LUFTFARTSDIREKTORATET
Avd. for Luftfartsinspeksjon
FORNEBU-OSLO/Dep.
Tlf. : Oslo (02) 12 13 40
AFTN: ENFBYA
Tlgr. : CIVILAIR OSLO
Telex : 11032 Oslo

LUFTDYKTIGHETSPÅBUD

MAULE
SAMMENDRAG
1946 - 1970

MAULE - 3

Figure 1

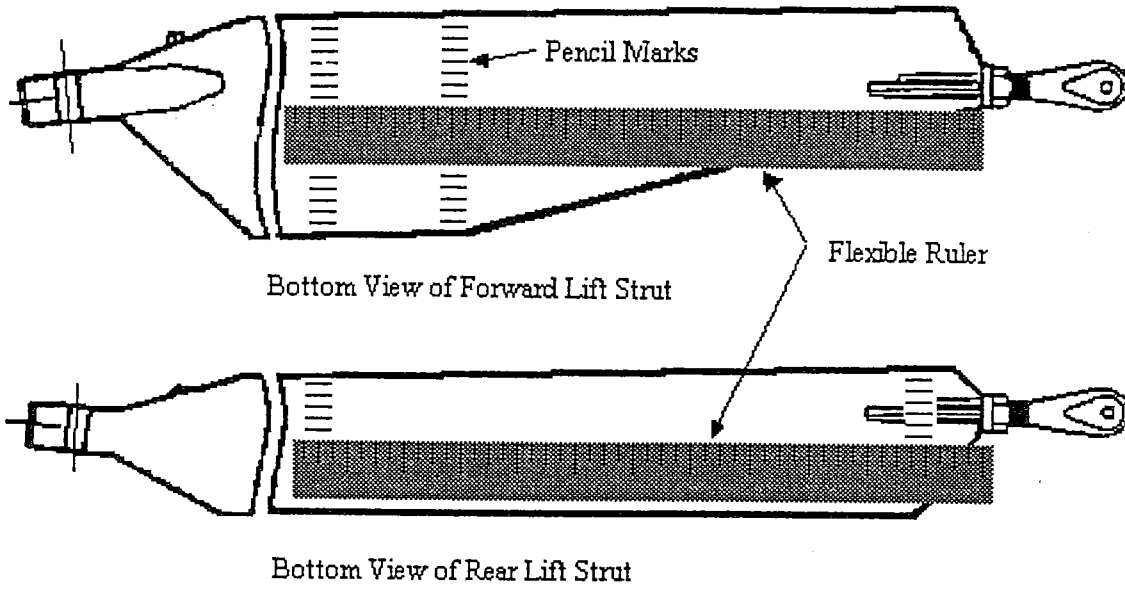
2. Using a flexible ruler, draw a 1/4-inch grid on the surface of the first 11 inches from the lower end of the strut as shown in Maule Service Bulletin No. 11, dated October 30, 1995, as applicable. This can be done using a soft (#2) pencil and should be done on both faces of the strut. As an alternative to drawing a complete grid, make two rows of marks spaced every 1/4 inch across the width of the strut. One row of marks should be about 11 inches from the lower end of the strut, and the second row should be several inches away where the strut starts to narrow. Lay the flexible ruler between respective tick marks of the two rows and use tape or a rubber band to keep the ruler in place. See Figure 1.

3. Apply a generous amount of couplant inside each of the square areas or along the edge of the ruler. Re-application of couplant may be necessary.
4. Place the transducer inside the first square area of the drawn grid or at the first 1/4-inch mark on the ruler and "ring" the transducer to the strut. When using a dual element transducer, be very careful to record the thickness value with the axis of the transducer elements perpendicular to any curvature in the strut. If this is not done, loss of signal or inaccurate readings can result.

8. A measurement of 0.024 inch or less shall require replacement of the strut prior to further flight.
9. If at any time during testing an area is encountered where a valid thickness measurement cannot be obtained due to a loss of signal strength or quality, the area shall be considered suspect. These areas may have a remaining wall thickness of less than 0.020 inch, which is below the range of this setup, or they may have small areas of localized corrosion or pitting present. The latter case will result in a reduction in signal strength due to the sound being scattered from the rough surface and may result in a signal that includes echoes from the pits as well as the backwall. The suspect area(s) shall be tested with a Maule "Fabric Tester" as specified in Maule Service Bulletin No. 11, dated October 30, 1995.
